Technical change for cap nut V1 and V4

- PCN-PB47-20210412-00-A
- 12.04.2021

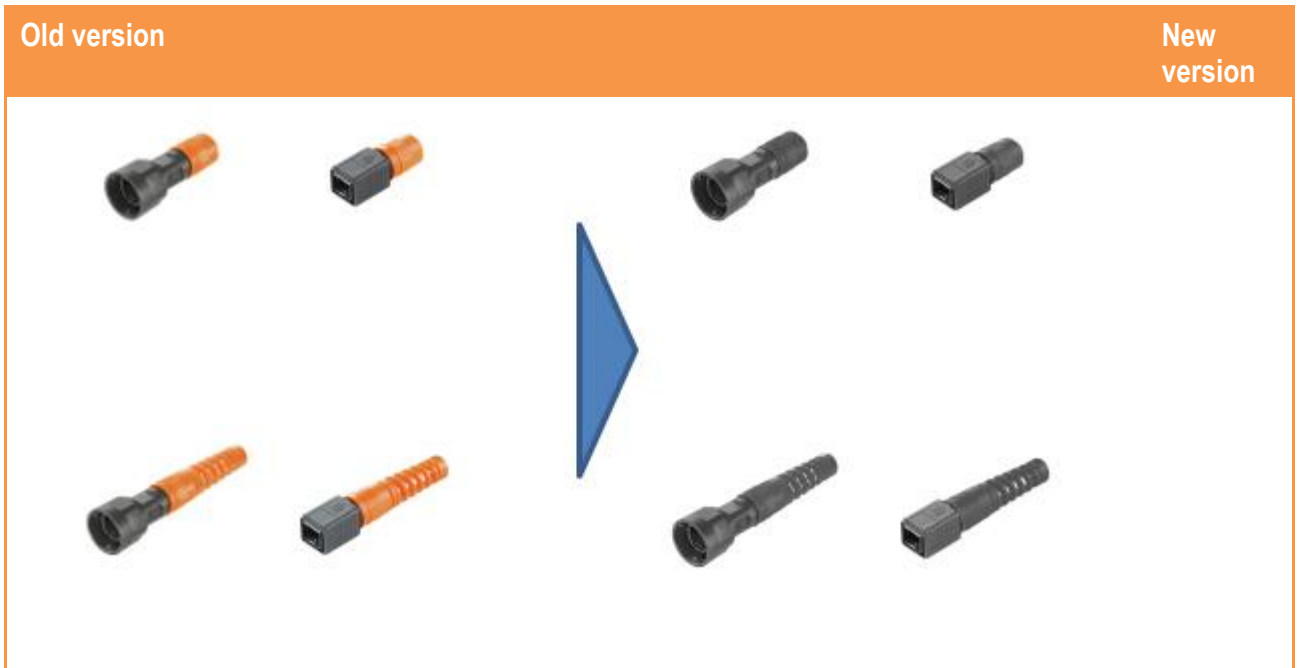
- The color of the cap nuts changes from orange to black. There are no further changes or technical deviations.
